JUSTIFICATION  
REMOVAL OF INTERNAL CASEMENT WINDOWS

107 HIGH STREET, LINDFIELD, HAYWARDS HEATH, RH16 2HR

Drawing GH342 PL02 Rev B approved drawings under application DM/22/3694 & DM/22/3695

Pre-construction photograph of low quality casement window, west facade (ground floor). Foam around the frame visible.

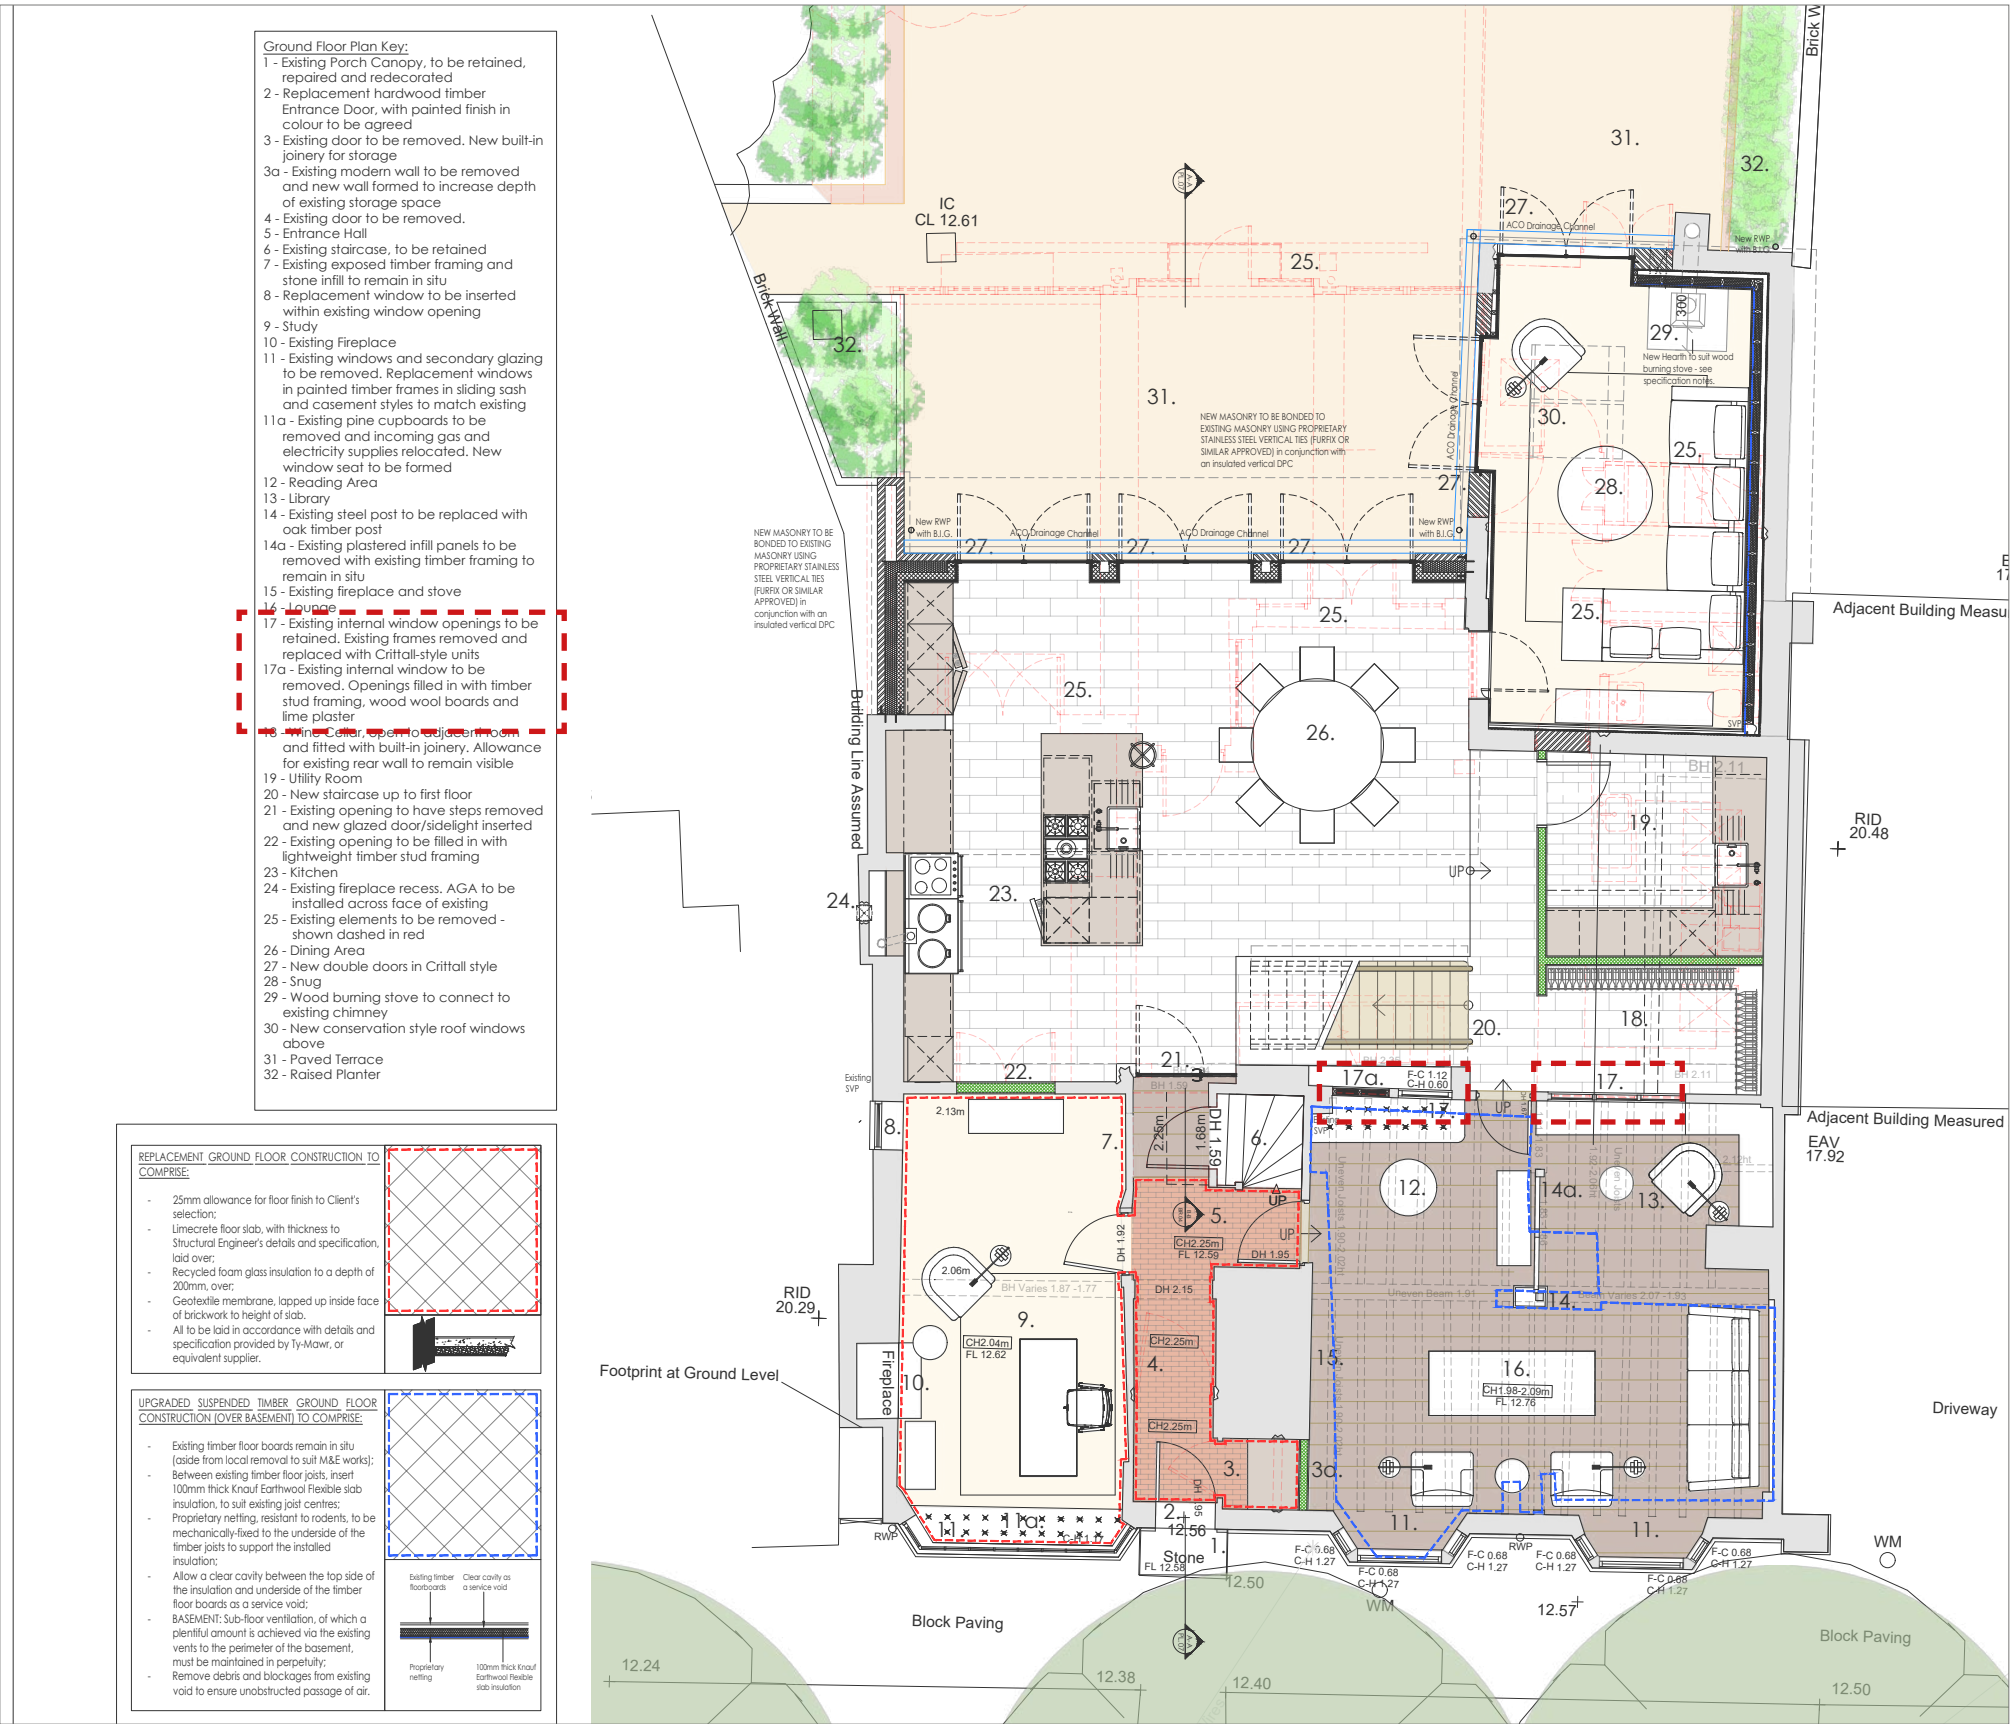
Point 17 of the approved drawing GH342 PL02 Rev B confirms removal of eexisting casement windows.

Point 17a, relating to the internal opening adjacent to the corkscrew staircase, confirms filling in of the opening with timber stud framing, wood wool boards and lime plaster.

*‘17 - Existing internal window openings to be retained. Existing frames removed and replaced with Crittall-style units*  
*17a - Existing internal window to be removed. Openings filled in with timber stud framing, wood wool boards and lime plaster.’*

Drawing GH342 PL03 Rev C approved drawings under application DM/22/3694 & DM/22/3695

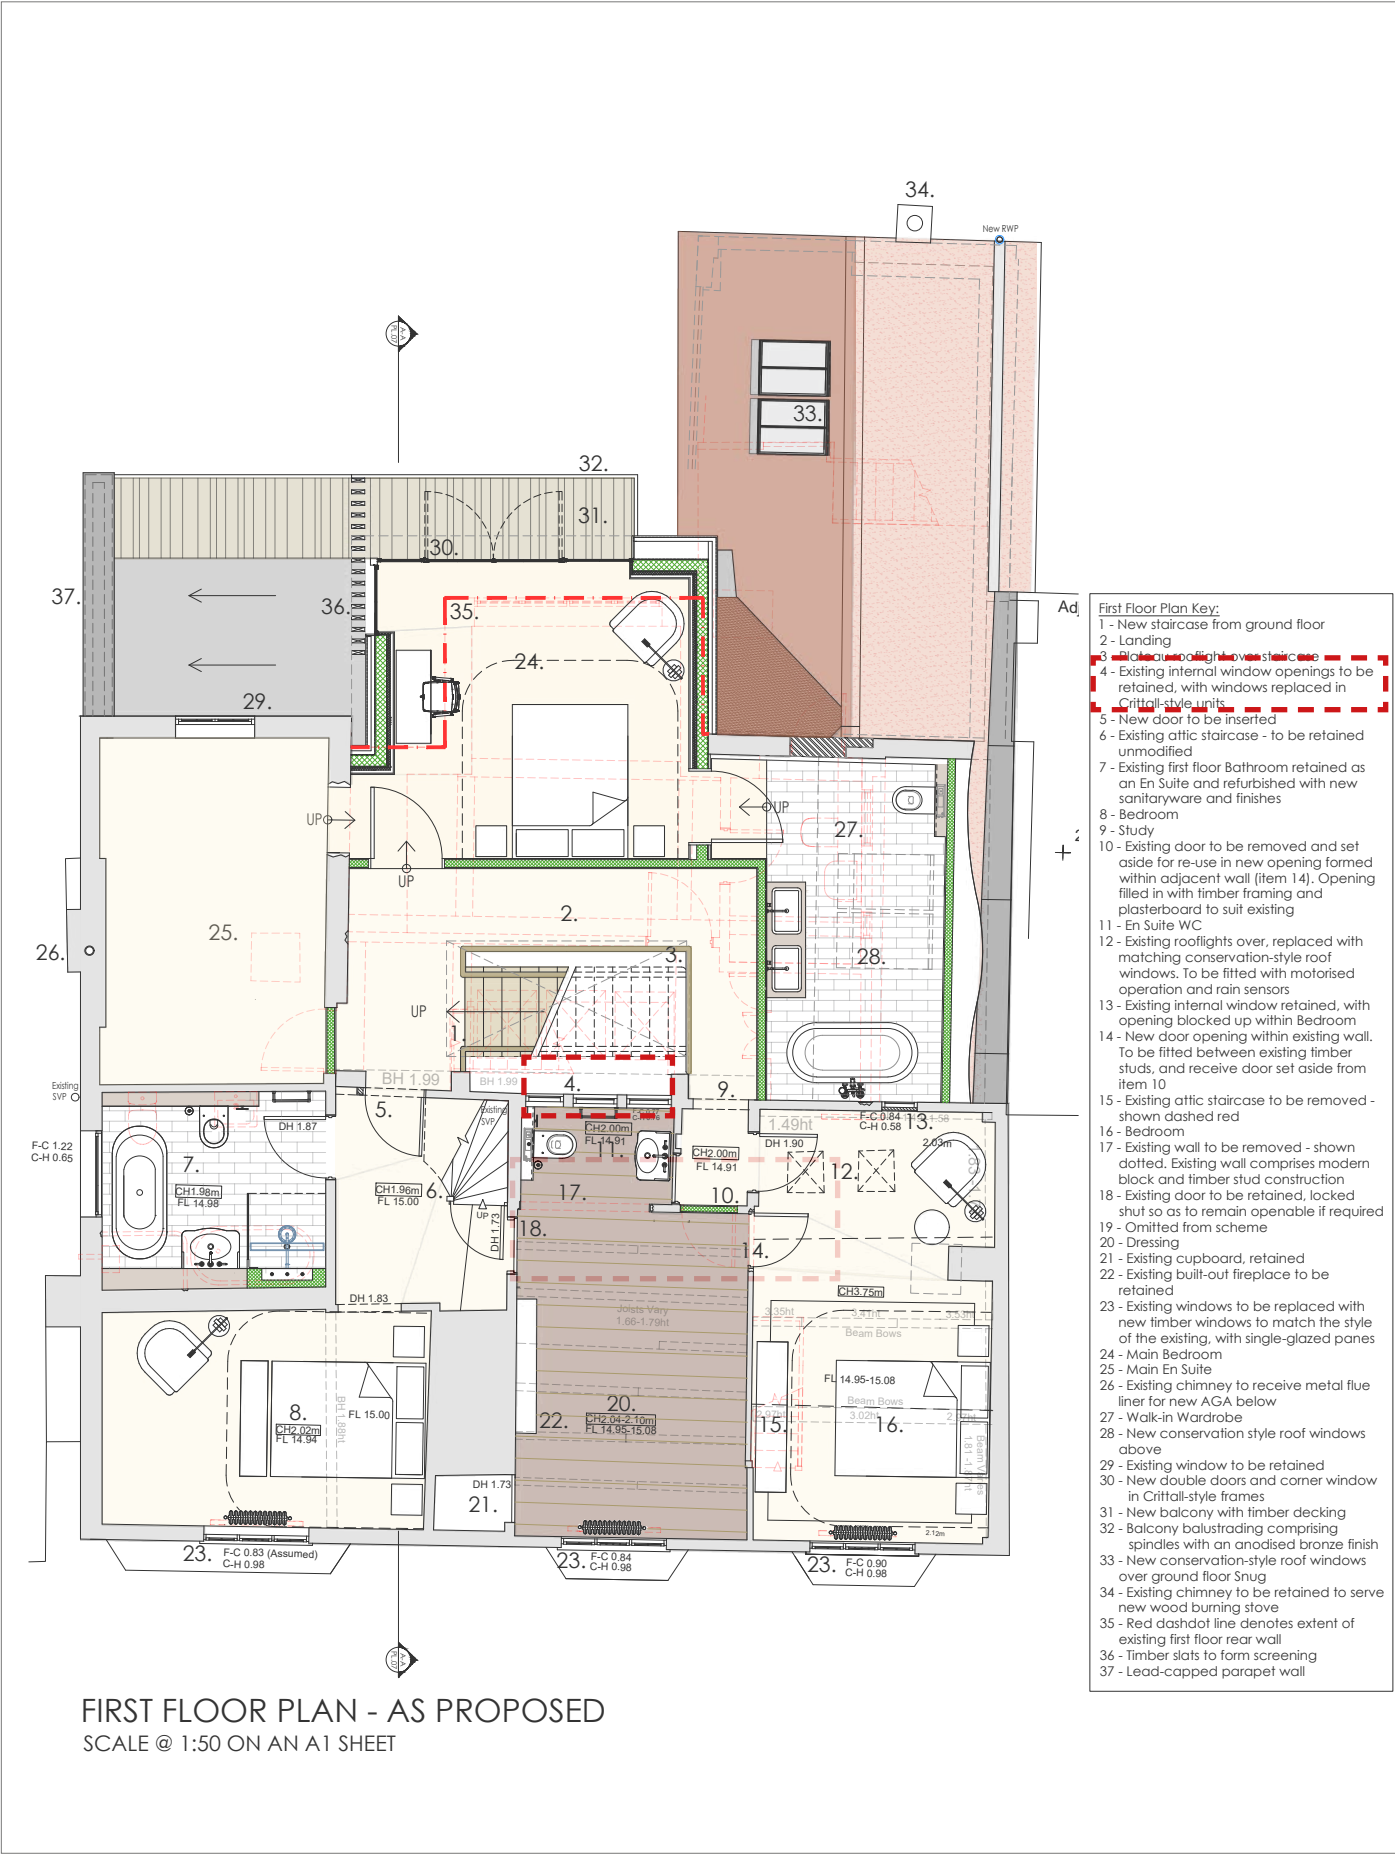
Point 4 of approved drawing GH342 PL03 Rev C confirms removal of existing windows and replacement with crittall-style units. This has been partially implemented by removal of windows. The openings were blocked up with wood wool and lime plaster, which was a more in-keeping solution.

*‘4 - Existing internal window openings to be retained, with windows replaced in Crittall-style units’*

JUSTIFICATION  
TERRACE BALUSTRADE

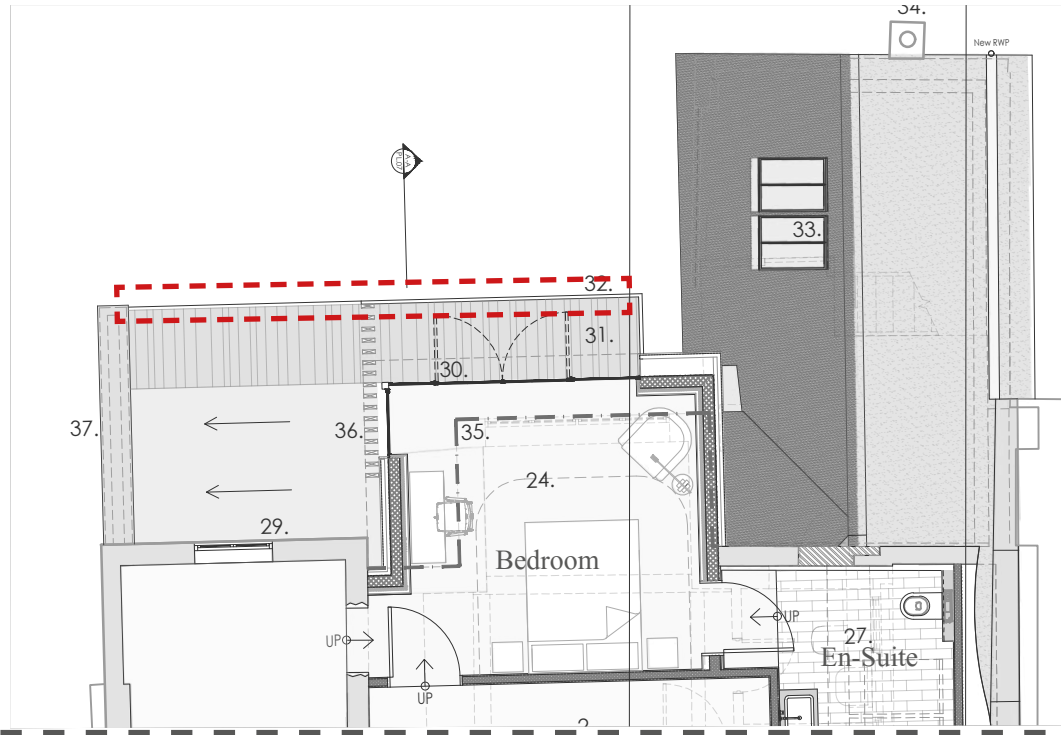
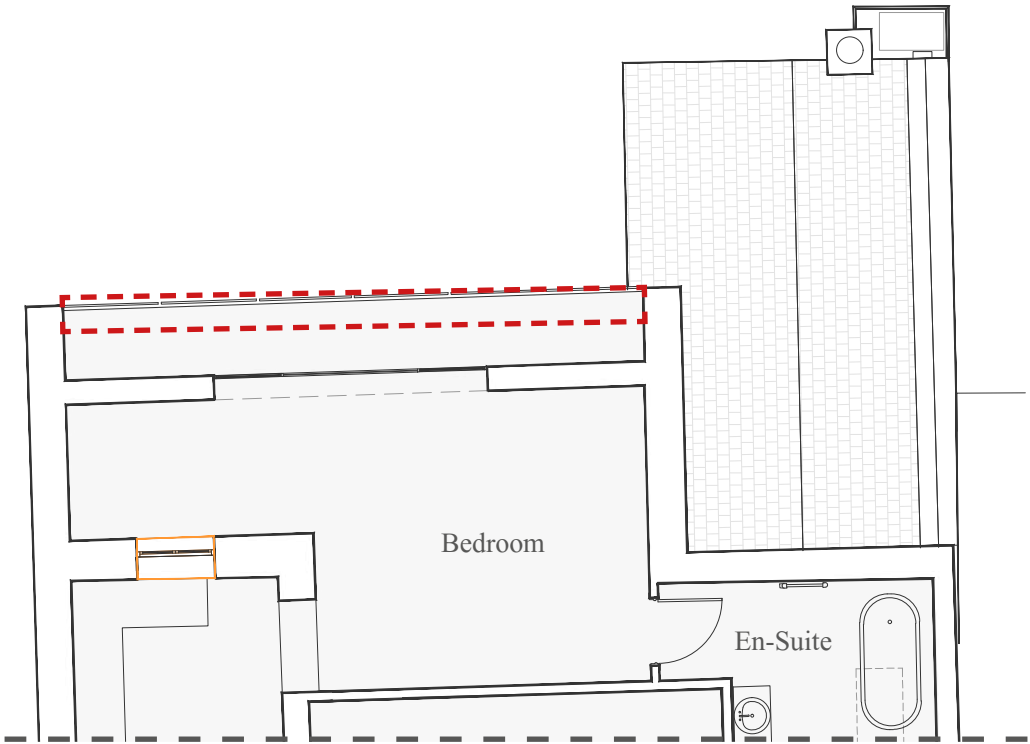
The constructed balustrade to the rear elevation is a deviation  
The balustrade to rear terrace has been constructed in deviation to the approved scheme. Due to the increased width of the ‘as-built’ extension the current balustrade has more length. Its design has been changed from metal rail with balusters to a frameless glazing system.

The change to a frameless glazing system is more discreet and visually seamless, reducing the visual obstruction of the overall appearance of the facade, creating less distraction and visual clutter. According to the supporting HCUK Heritage Statement, it is considered to have neutral impact on the significance of the listed building.

As noted previously, the approved drawings of application DM/22/3694 & DM/22/3695 are not consistent. The balustrade appears to span full length of the rear extension on the plan, which is what was implemented.

Recent photographs of timber weatherboarding

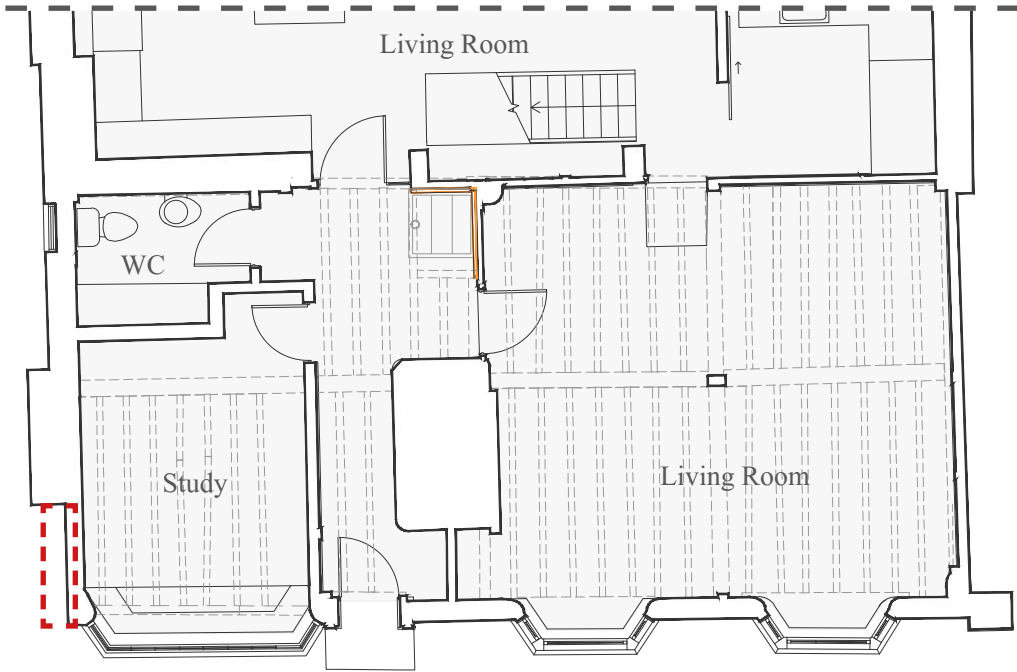
It was approved for the existing timber weatherboarding to the return corner of the front (East) and side (South) elevation to be extended down to ground level.

Leaving it as it is retains the legibility of a possibly truncated timber jetty as well as the exposed timber framing and brick nogging to this return elevation. Under-implementation of this change is preferable in heritage terms.

Approved Scheme  
Section AA

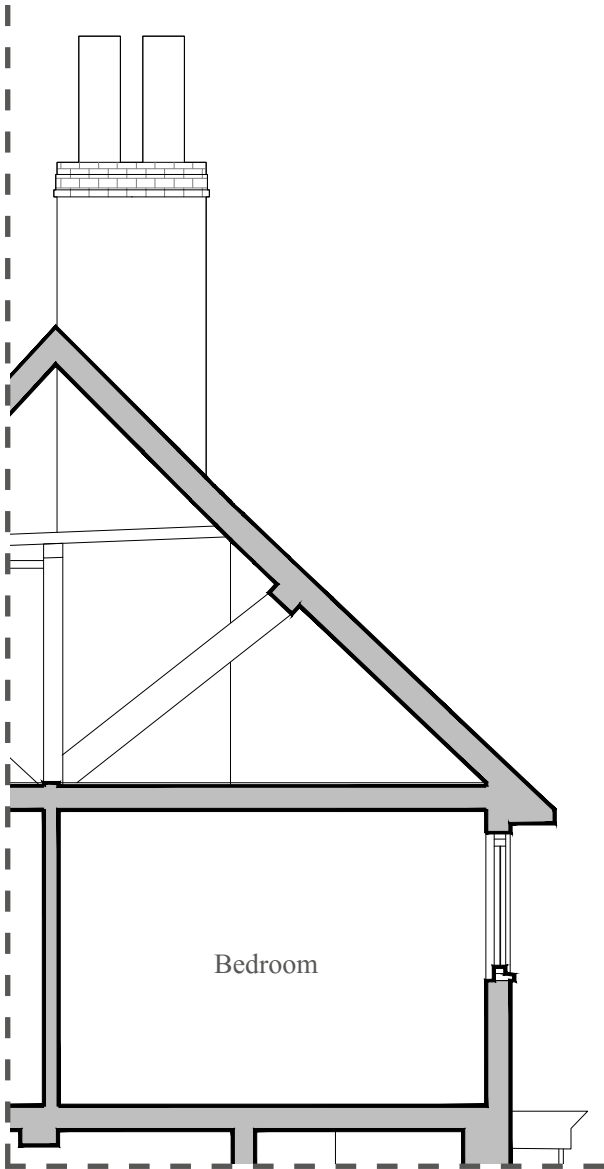
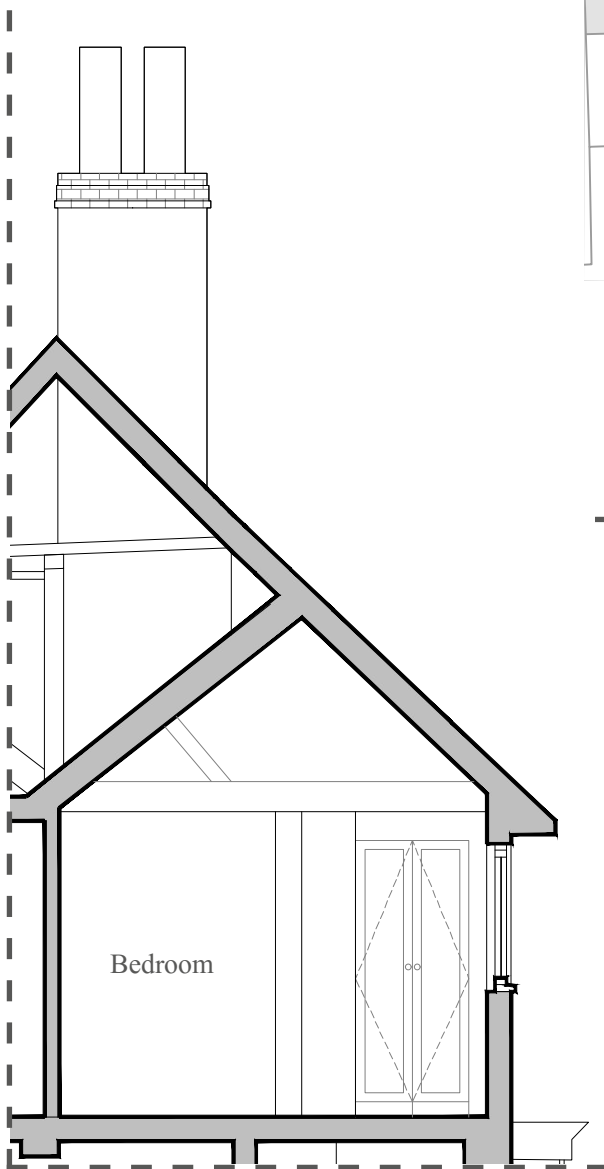
The approved documents and drawings contain conflicting information relating to this aspect of the scheme; this is confirmed on point 27 on drawing GH342 PL 07 B, but not clearly shown on the drawn content.

The modern ceiling build up with timber joists and gypsum plasterboard finish have been removed in the SE bedroom, with the creation of a vaulted ceiling. This has been created utilising reclaimed timber oak timber rafters with lime plaster infill. It is proposed to retain these works.

According tot the supporting HCUK heritage statement, this change has an ostensibly neutral impact on the listed building’s significance but is undoubtedly an improvement on the approved scheme which reinforces historic character and quality of the bedroom space.

Pre-construction photograph - steel post supporting timber frame

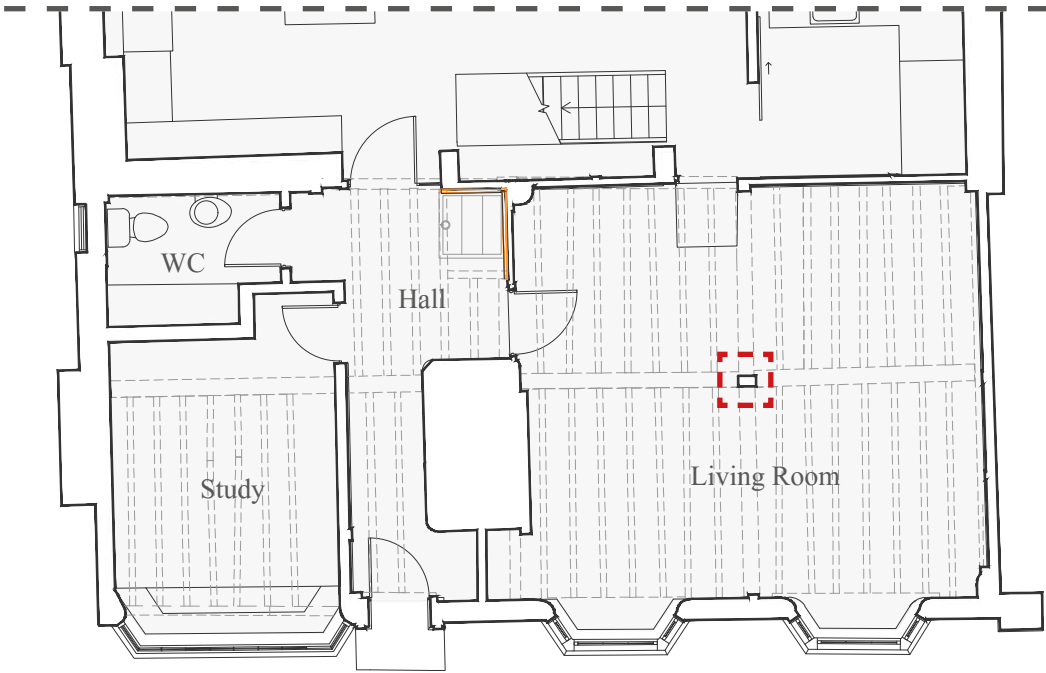
The replacement of the steel post propping the building’s timber frame has been approved at planning. This has been implemented and the steel post was replaced with a traditional gun stock post in seasoned oak. HCUK Heritage Report notes that:

*‘this intervention represents a significant improvement on the improvised steel post and Acro-prop arrangement which it replaced. The Oak post is of a traditional design, with tapering ‘gunstock’ jowls. It is a credible and archaeologically accurate form of repair which nonetheless reads as honest and new.’*

This repair is of clear heritage benefit.
